Hunter F. Mk. 6 Aircraft—Oxygen System, Valve, Mk. 10 (Ref. No. 6D/1872) Introduced in place of Valve, Mk. 8* (Ref. No. 6D/223)—
Part (A) Provision for, Part (B) Valve

(MOD. No. HUNTER/539.)

Hunter F. Mk. 6 Aircraft—To make provision for the introduction of Oxygen Demand Regulator Mk. 17D (Ref. No. 6D/1966) in place of Mk. 17 (Ref. No. 6D/1700) or Mk. 17B (Ref. No. 6D/1710)

(MOD No. HUNTER/678.)

DRG. No. A.P. 4347F/O.1/57

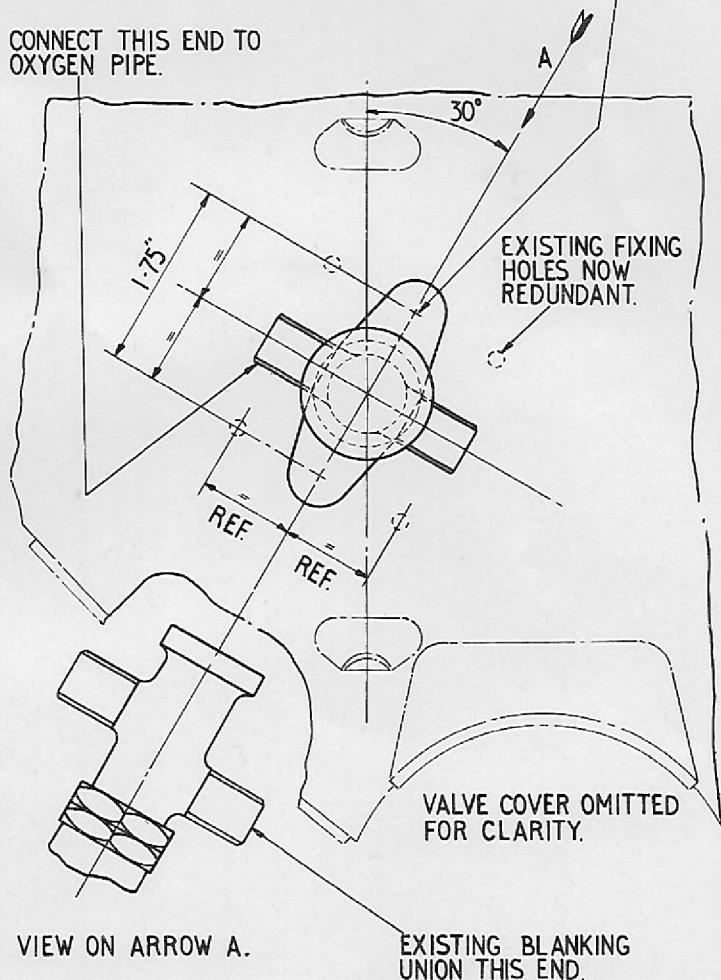
- Through nose wheel aperture, locate oxygen charging valve on forward, lower, starboard side of frame 6.
- Remove the protective cover from the valve.
- Disconnect and remove valve, retaining fixings (A.P.4347, Vol. 1, Sect. 3, Chap. 10 refers).
- Modify frame 6 as shown on the drawing.
- Refit valve as before using existing fixings (A.P.4347, Vol. 1, Sect. 3, Chap. 10 refers).

- Through nose wheel aperture, locate oxygen charging valve on forward, lower, starboard side of frame 6.
- Remove the protective cover from the valve.
- Disconnect and remove the valve, Mk. 8* (A.P.4347, Vol. 1, Sect. 3, Chap. 10 refers).
- Fit new valve, Mk. 10, Ref. No. 6D/1872 using new bolts, Part No. A.25-6-C and two existing nuts and washers as shown on the drawing (A.P.4347, Vol. 1, Sect. 3, Chap. 10 refers).

DRILL 2 HOLES
MORSE № 10
IN FRAME

BOLT
HEADS
ON AFT
FACE

WASHER
EXISTING.

NUT

CONNECT THIS END TO
OXYGEN PIPE.

FRAME 6 LOOKING AFT STBD SIDE.

Drawing No. A.P.4347F/0.6/62 is incorporated in this leaflet.

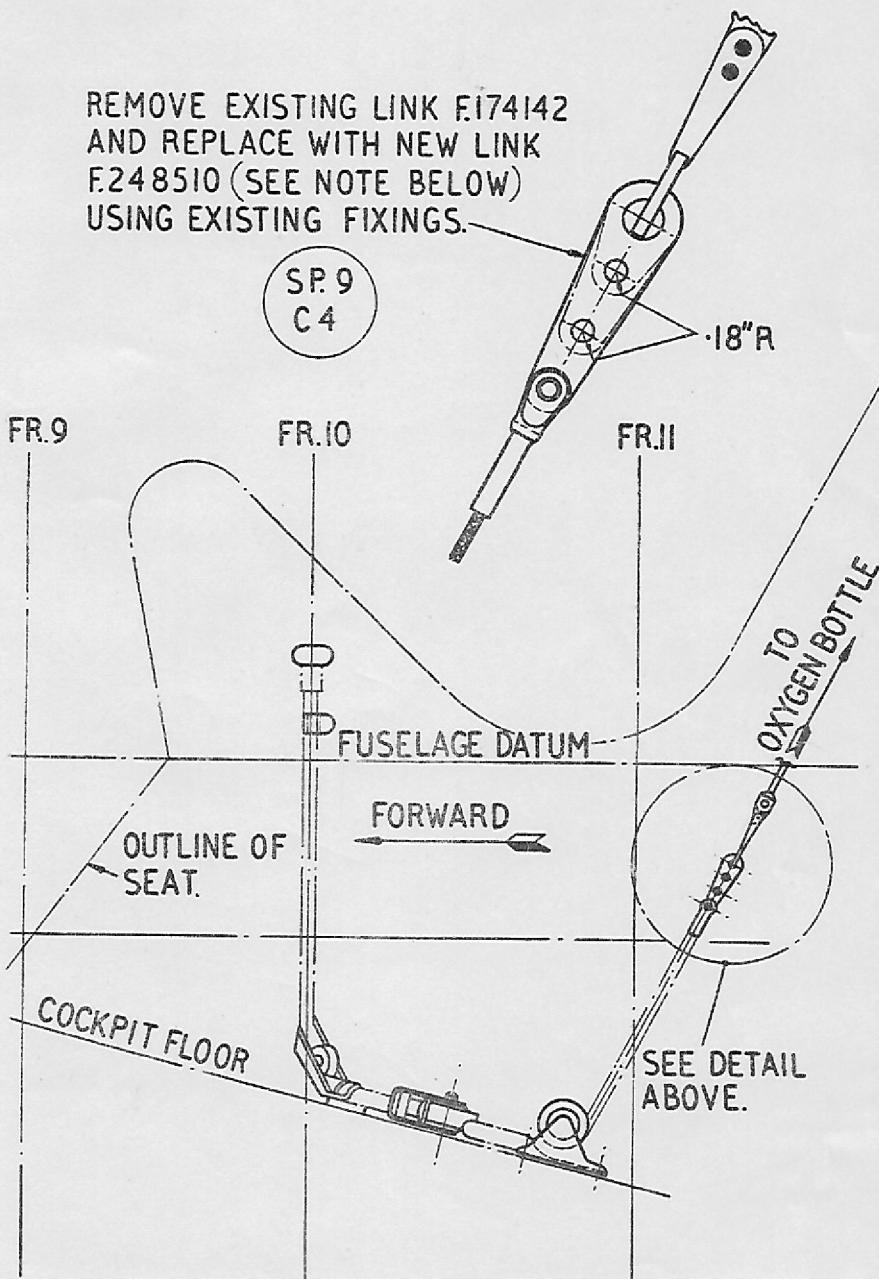
AL 621
Operation (2) Remove the existing link Part No. F.174142. between the

THE FIXING POSITION, as shown on the drawing.

(4) Fit link to end of control cable, using existing pin with new split pin, Part No. SP.9.C.4, as shown on the drawing.

(5) Re-connect the link to hook on oxygen bottle assembly, as shown on the drawing.

REMOVE EXISTING LINK F174142
AND REPLACE WITH NEW LINK
F248510 (SEE NOTE BELOW)
USING EXISTING FIXINGS.

TO TAKE UP SLACK IN WIRE, ADJUST LENGTH BY
PICKING UP APPROPRIATE HOLE IN LINK, AND IF
NECESSARY CUT OFF REDUNDANT LENGTH OF LINK.
